Application of My Next Home Pro, LLC to rezone properties from C-1 (Local Commercial) zoning district to R-60 (Residential Small Lot-60) zoning district to construct a new single-family residence, at 711 & 705 Hillmont Avenue.

PETITION NO: N5-2026-0449 Z-26-1247887

Z-26-1247887 (2026-0449)
Recommended Conditions – May 2026
705 & 711 Hillmont Avenue

STAFF ANALYSIS

SITE PLAN

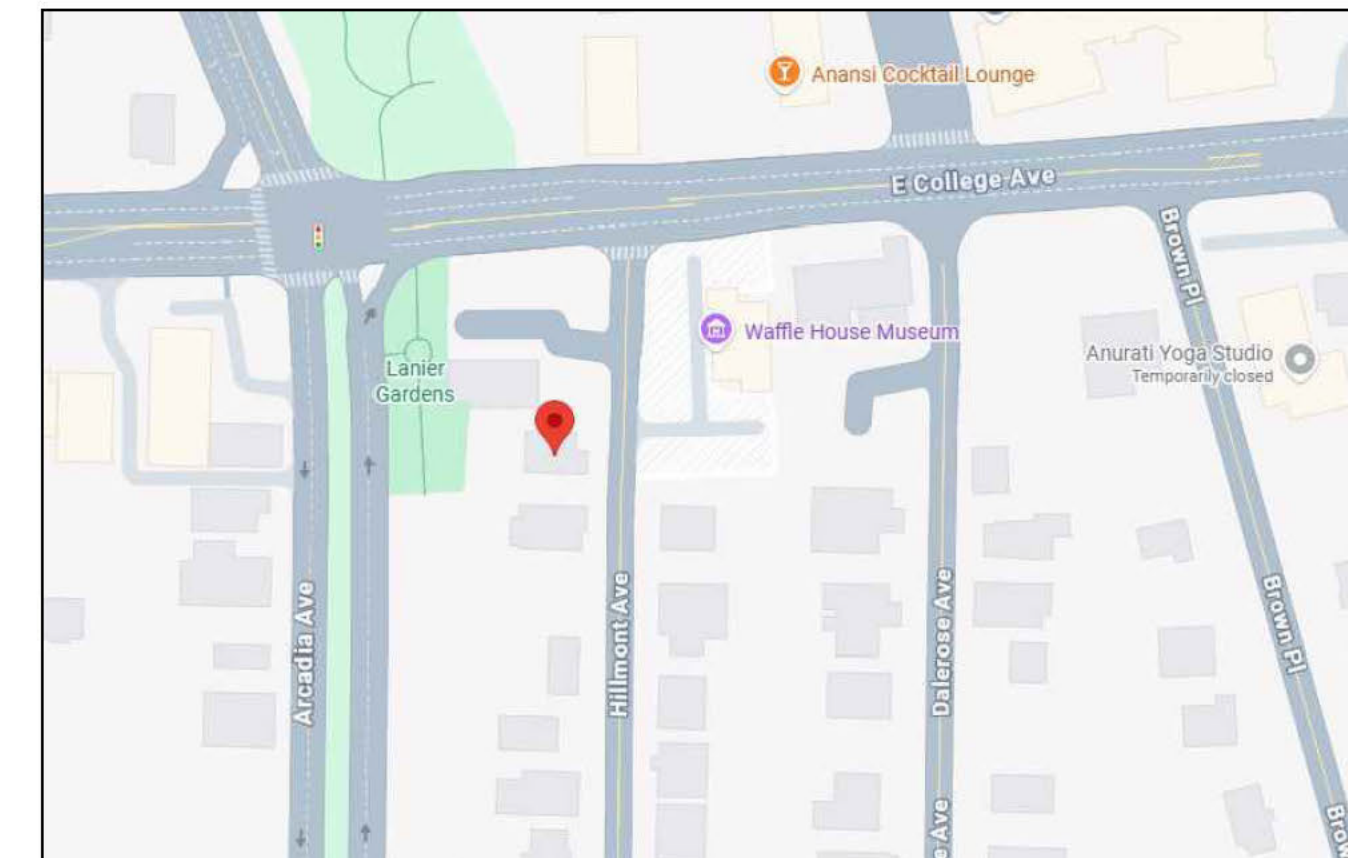
The proposed site plan and architectural plans submitted by the applicant displays a modern three (3)-story single-family house that appears to meet R-60 *Dimensional requirements* of Section 27-2.8.3 (*Table 4.1*). The house plans indicate a 3,639 square-foot heated area, an attached 474 square foot unheated garage, a 217 square-foot covered rear patio, and a partial roof deck patio on the 3rd floor of the home. Section 27- 2.8.3 and Table 4.1 of

the Zoning Ordinance state that the minimum lot size is 15,000 square feet with a maximum lot coverage of 35 percent. The minimum house size is 2,000 square feet heated along with a maximum height of 35 feet, with setbacks of 10 feet in front (with alley access), 7.5 feet on each side, and a 30-foot rear setback. There are no proposed variances.

SHEET TITLE:
PROPOSED
FRONT ELEVATION

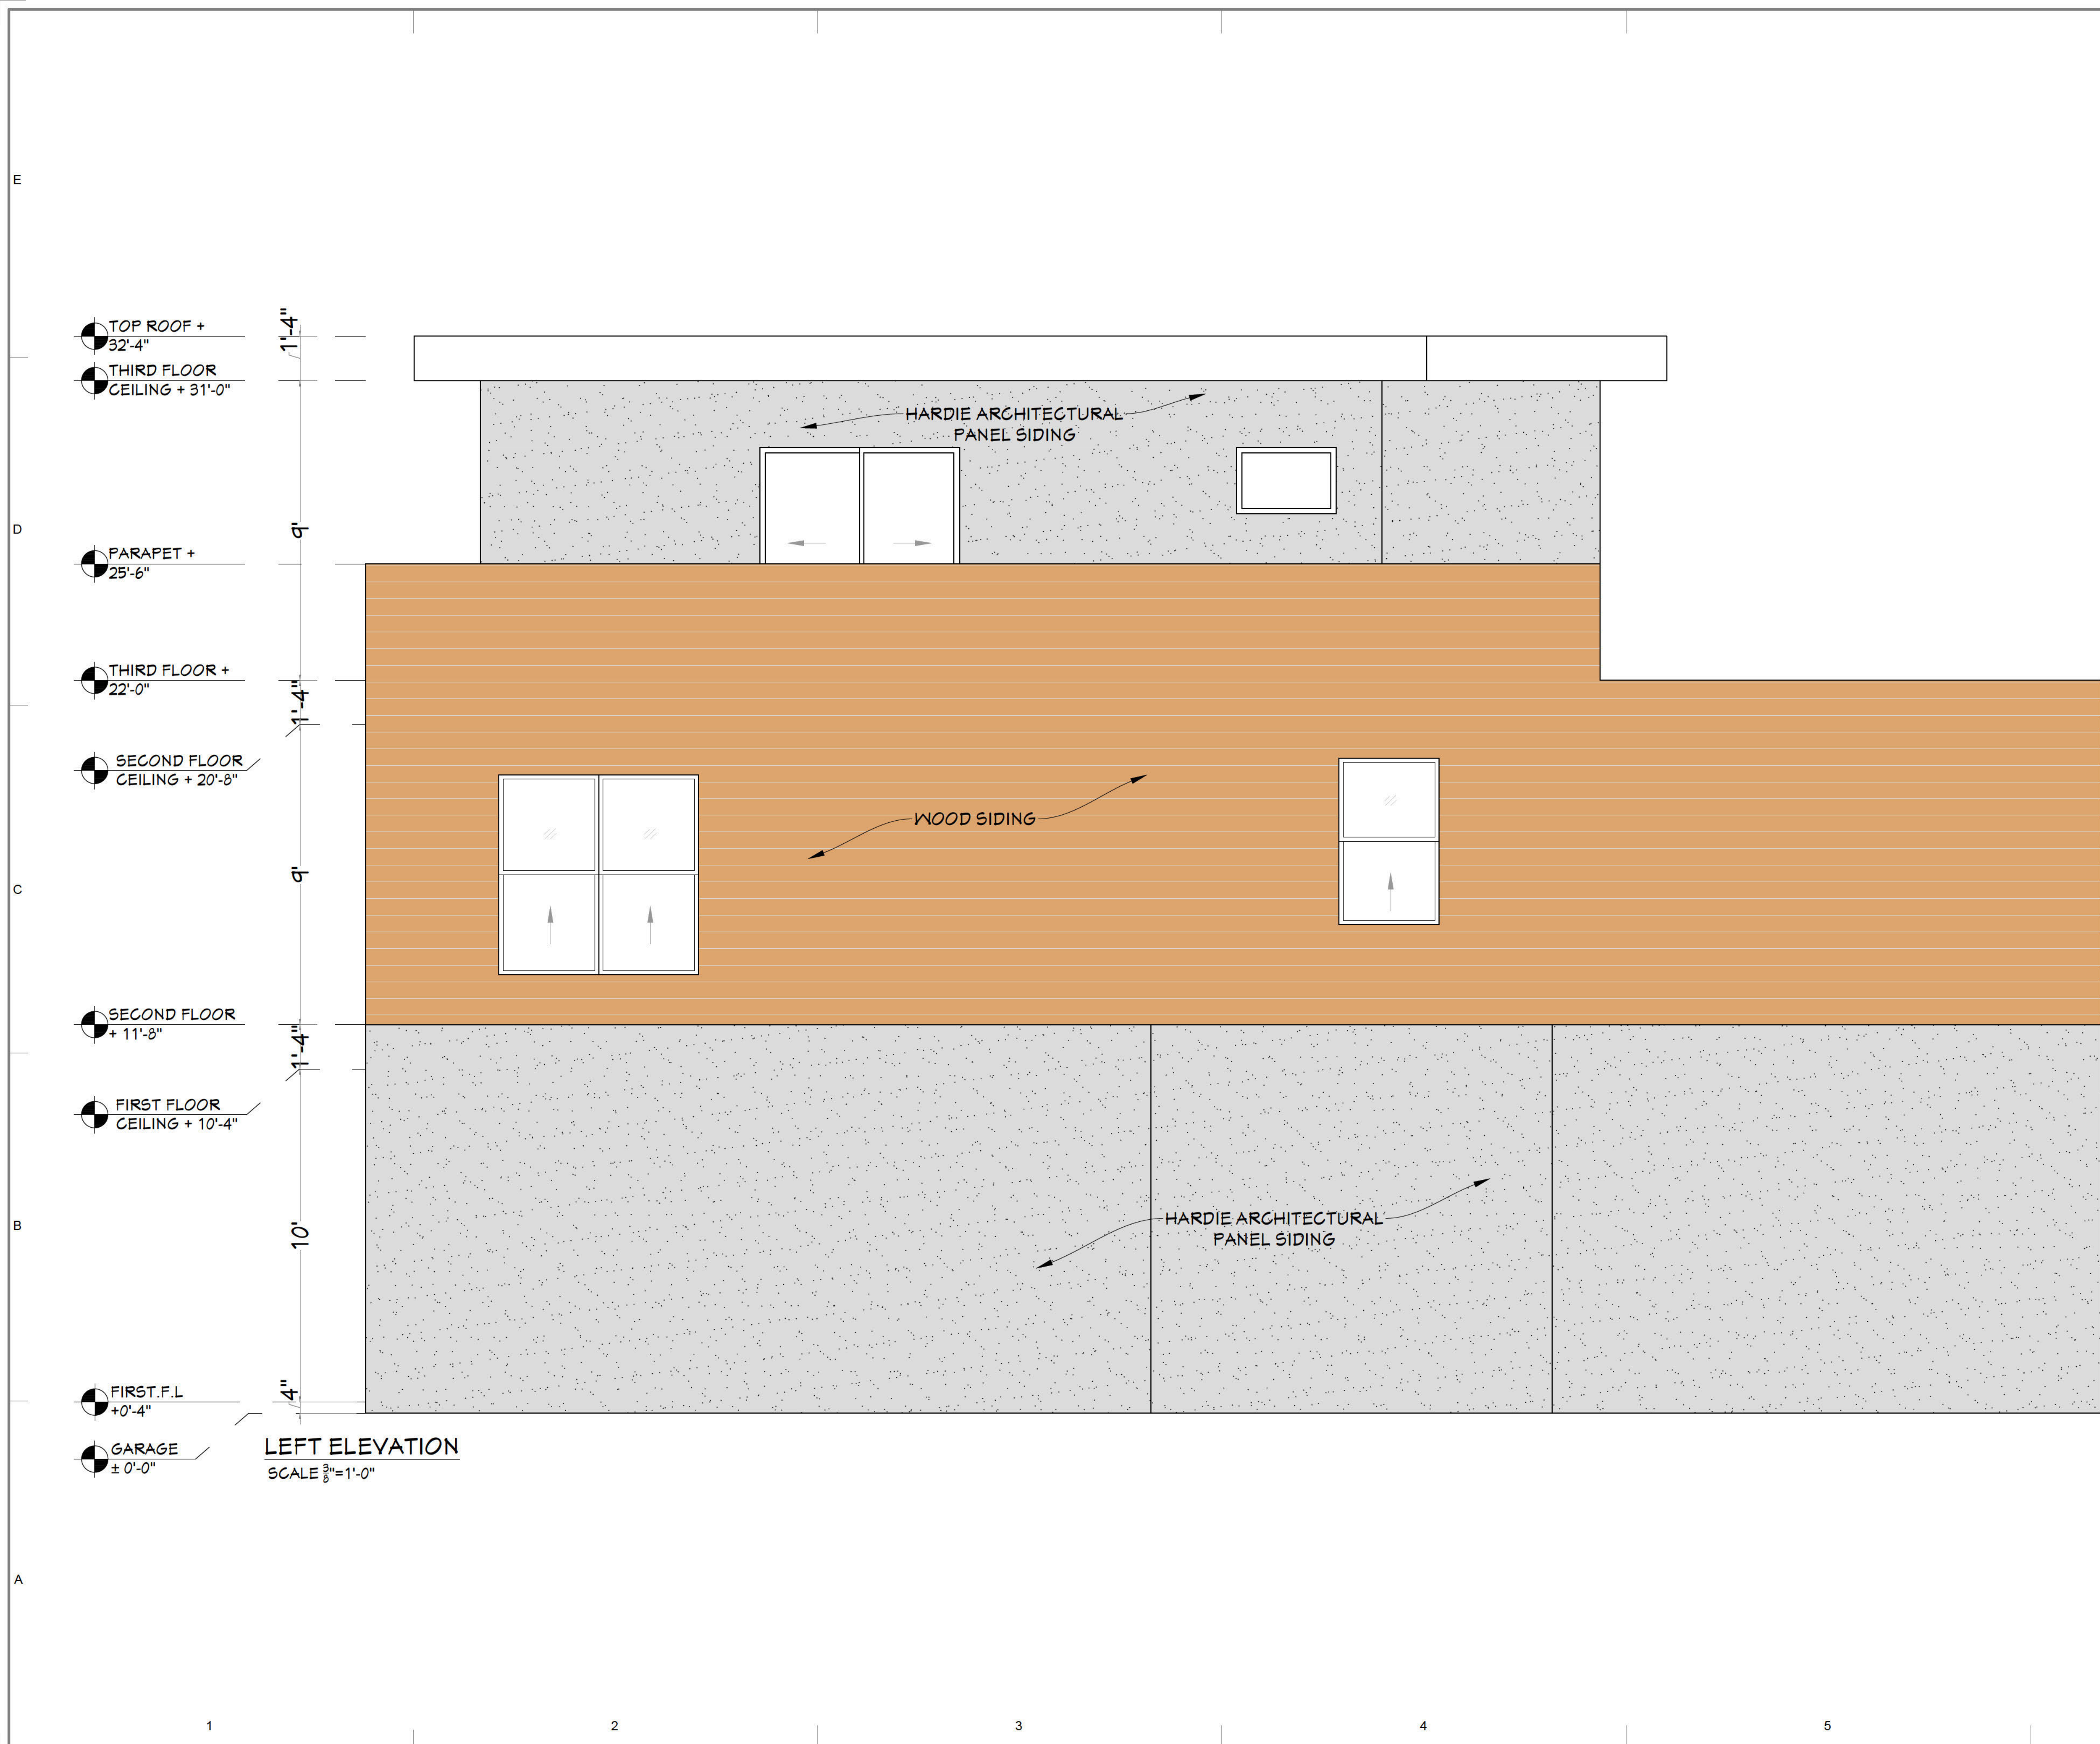
While the rezoning is consistent with the neighborhood, the proposed architectural design may not align with the existing development pattern along Hillmont Avenue. Accordingly, considerations to the re-design have been proposed by Staff to better align with the architectural character of the TN Character Area. Therefore, upon review of Section 5.3.4 (Rezone criteria A-N) of the Zoning Ordinance, Staff recommends ***"Approval with the following conditions"***:

- 1) The architectural plan will be redesigned to reflect a design that satisfies the intent and goal of the Traditional Neighborhood (TN). Such design will require written approval from the Planning Deputy Director prior to any permit.
- 2) A 5-foot landscape strip and 5-foot sidewalk must meet the requirements of Section 5.4.3 (Streetscape Elements and Dimensions) of the Zoning Ordinance, prior to the issuance of the Certificate of Occupancy (C/O).
